PITT-01-20-061

**Re: Sunoco Pipeline L.P. – Pennsylvania Pipeline Project (Mariner East II)
Chapter 102 Permit No. ESG0100015001 Major Modification – PA Turnpike/HDD 0280
Upper Uwchlan Township, Chester County, PA**

Technical Deficiencies

DATE:	2/6/17
PROJECT NO.:	112C05958
DESIGNED BY:	JB
DRAWN BY:	BH
CHECKED BY:	RS
COPYRIGHT:	TETRA TECH INC.
ES-6.25	
SHEET 6.25 OF 99

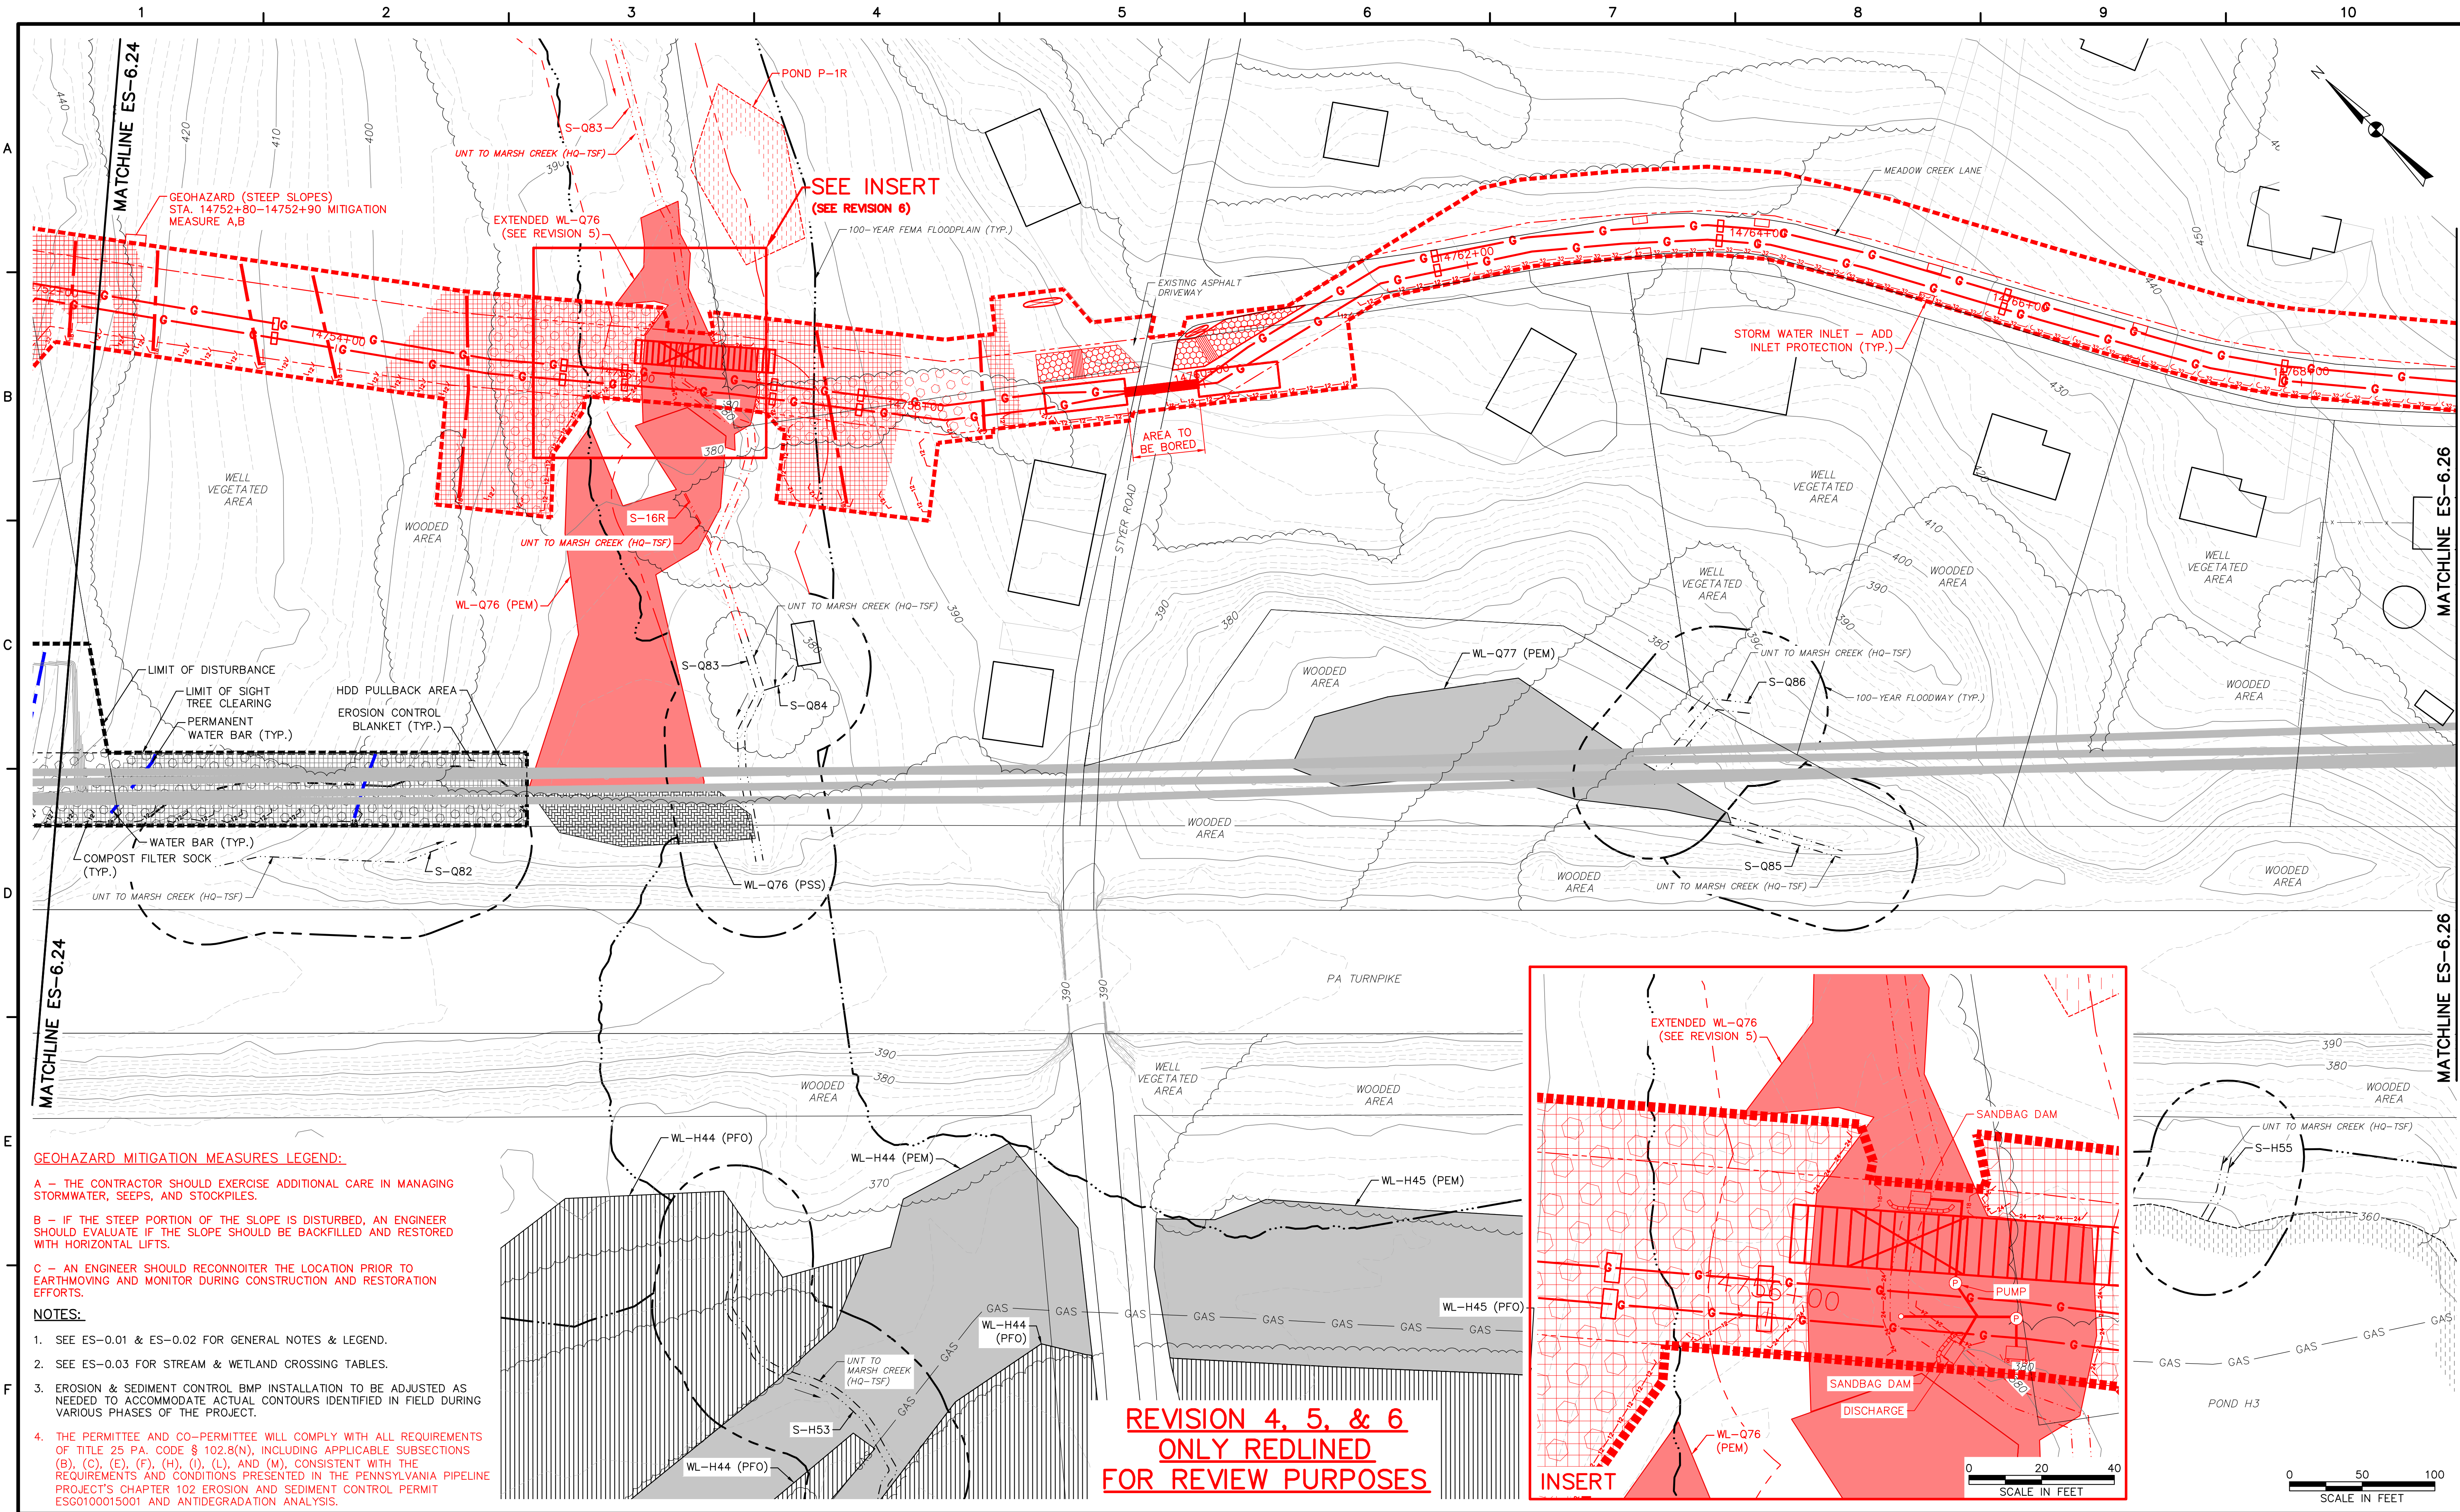
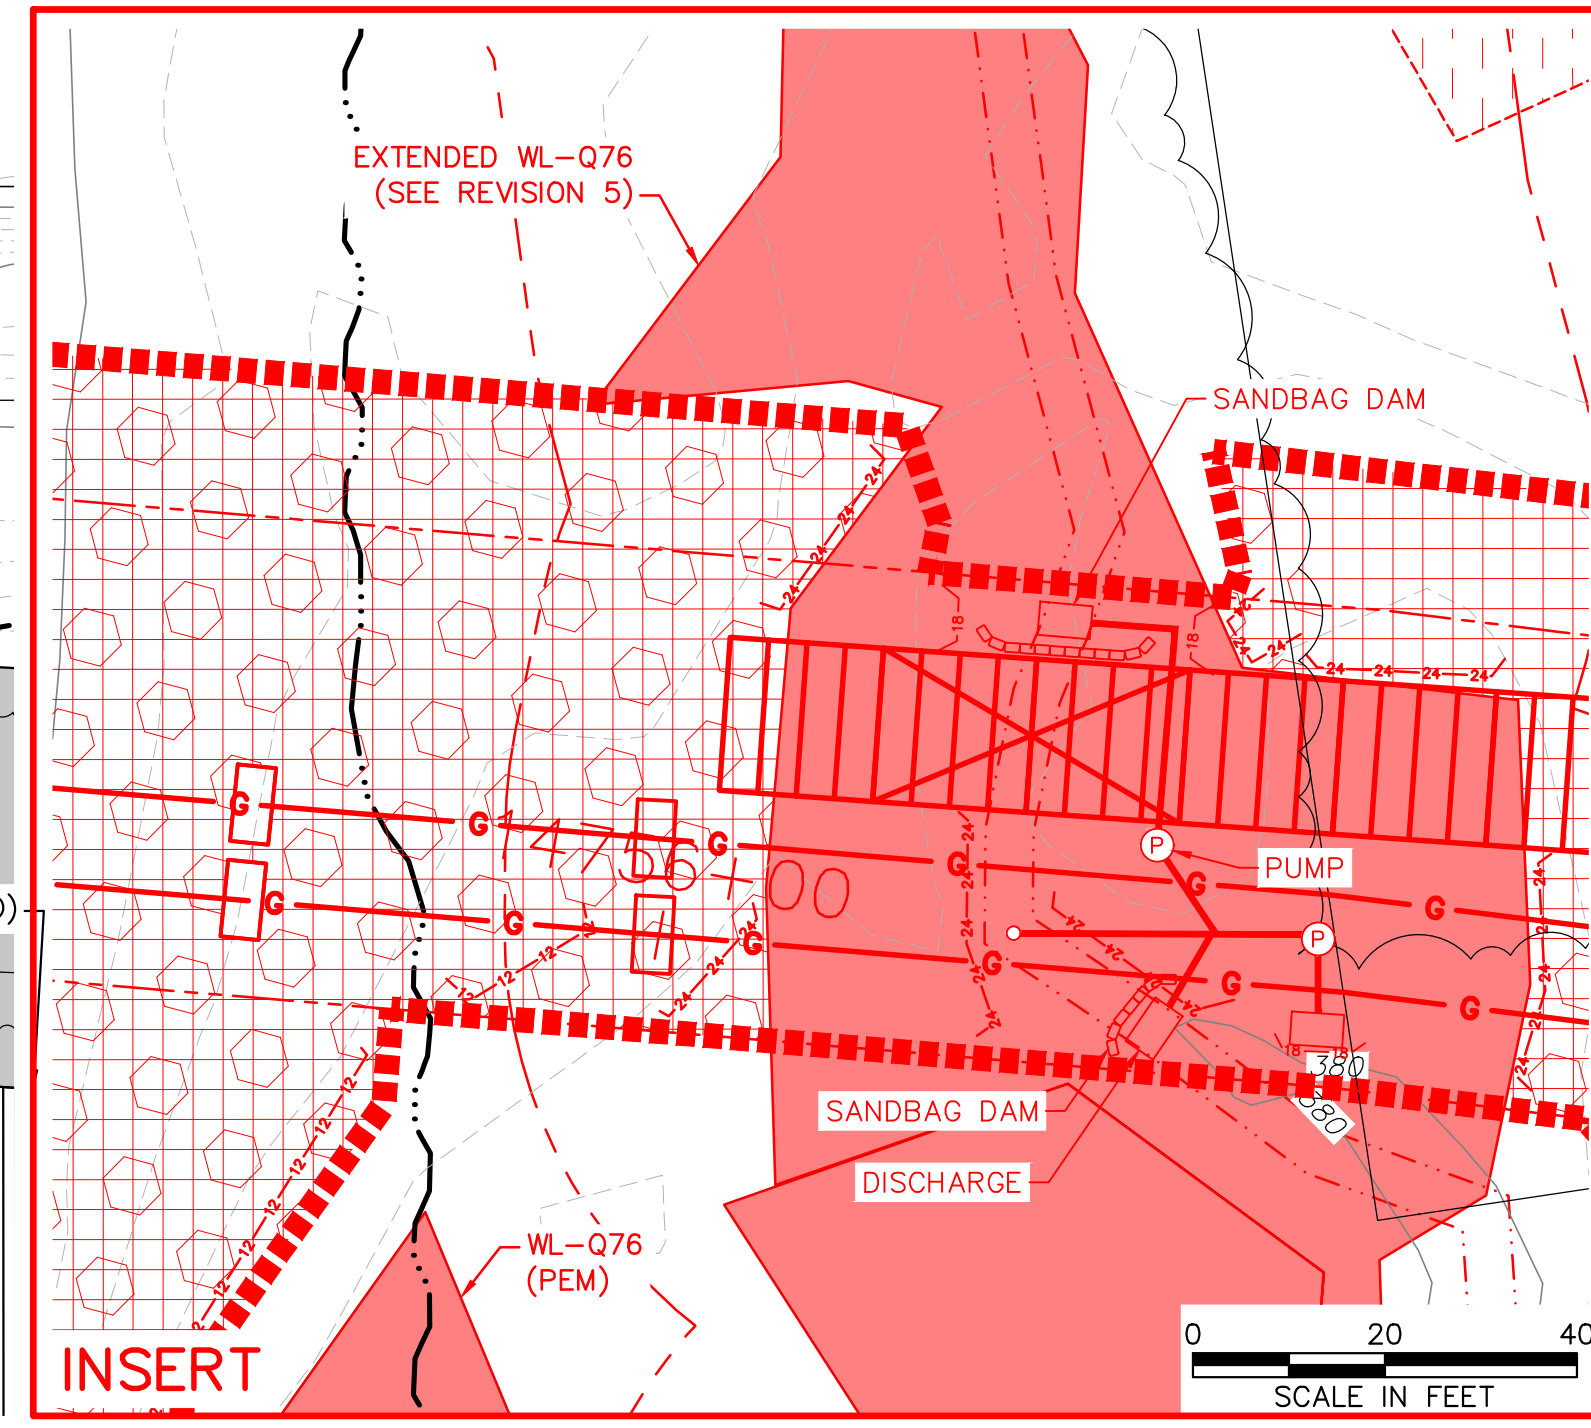
1. **Comment:** Please utilize a minimum of 24" Filter Sock adjacent to streams and wetlands. [102.4(c)]

5. **Comment:** Please provide a blow up of the stream/wetland crossing on the plan mapping and illustrate the proposed E&S controls for bypassing the stream flow both on the regular mapping and within the blow up insert. [102.11(a)(1)]

Response: Figure ES-6.25 has been revised to identify installation of 24-inch Compost Filter Sock (CFS) at wetland WL-076 and Stream S-Q83.

Response: *Drawing ES-6.25 has been updated to include a blow up of the stream/wetland crossing showing the dam and pump bypass.*

DATE: 2/6/17
PROJECT NO.: 112C05958
DESIGNED BY: JB
DRAWN BY: BH
CHECKED BY: RS
COPYRIGHT TETRA TECH INC.
ES-6.26
SHEET 6.26 OF 99

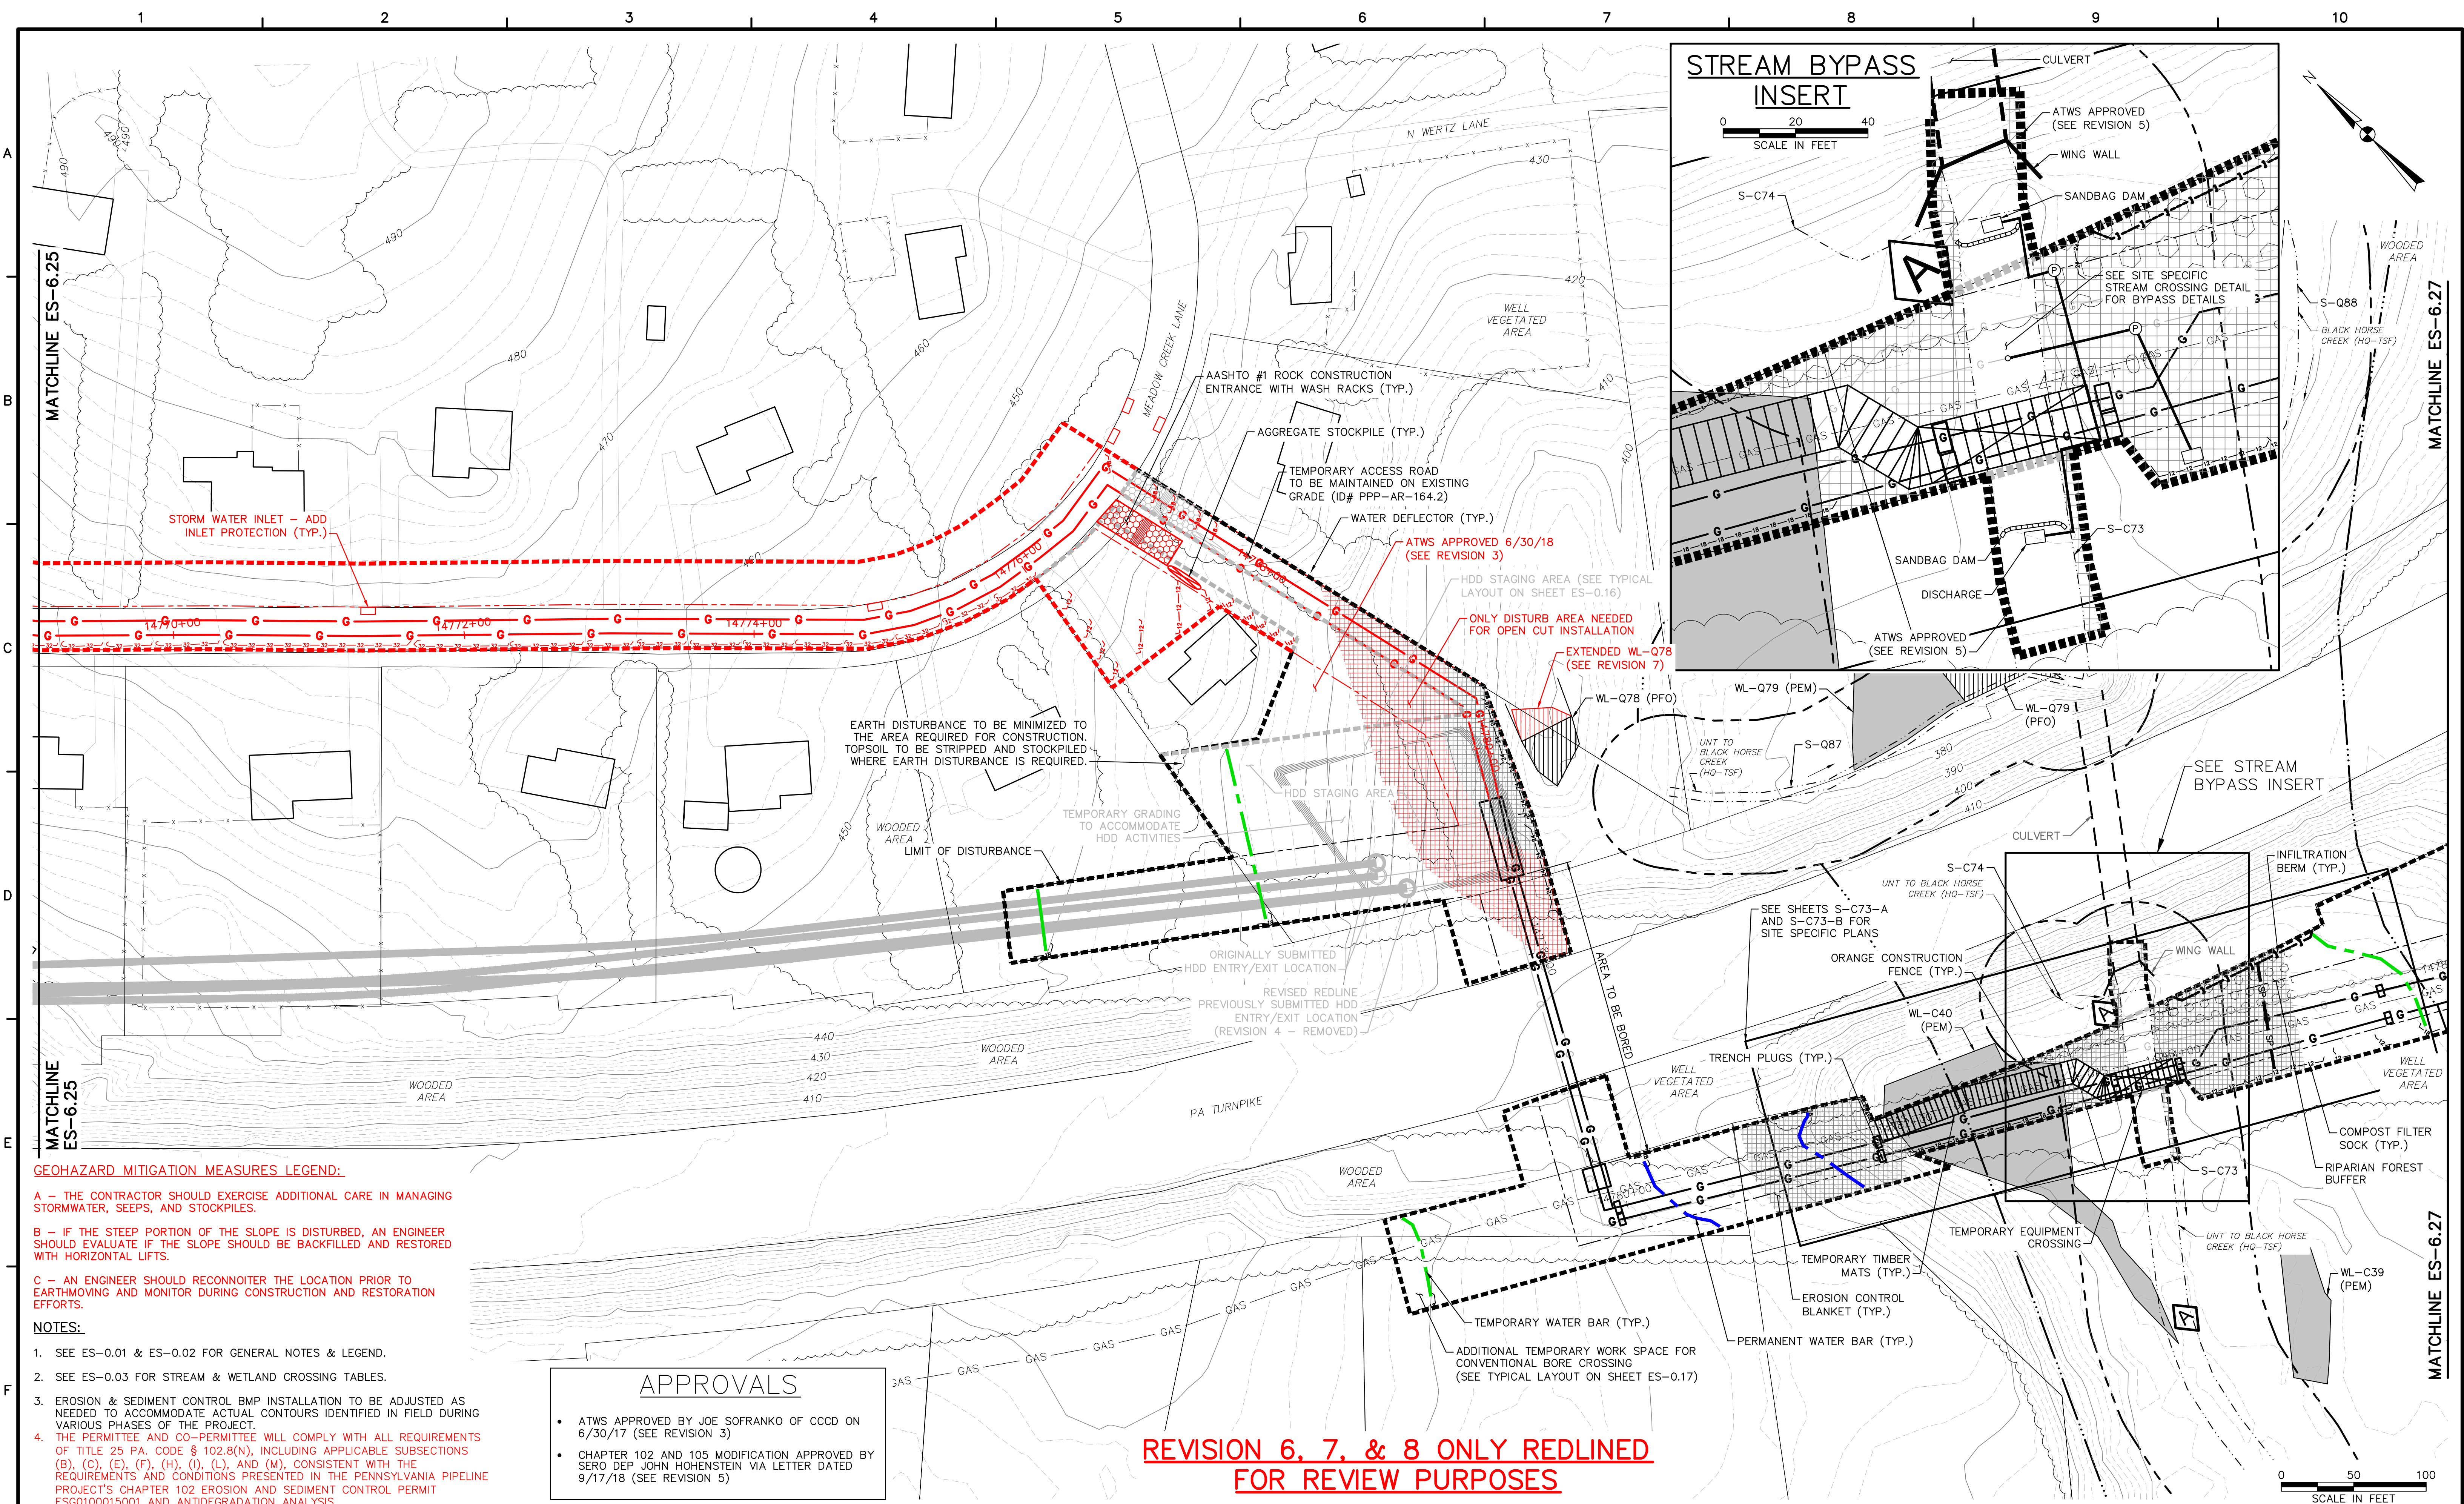
4. **Comment:** Please provide E&S controls from station 14778+00 to 14780+00 [102.11(a)(1)]

Response: *Drawing ES-6.26 has been updated to provide 18-inch CFS and note added to limit the area of disturbance to only the area needed for open cut installation.*
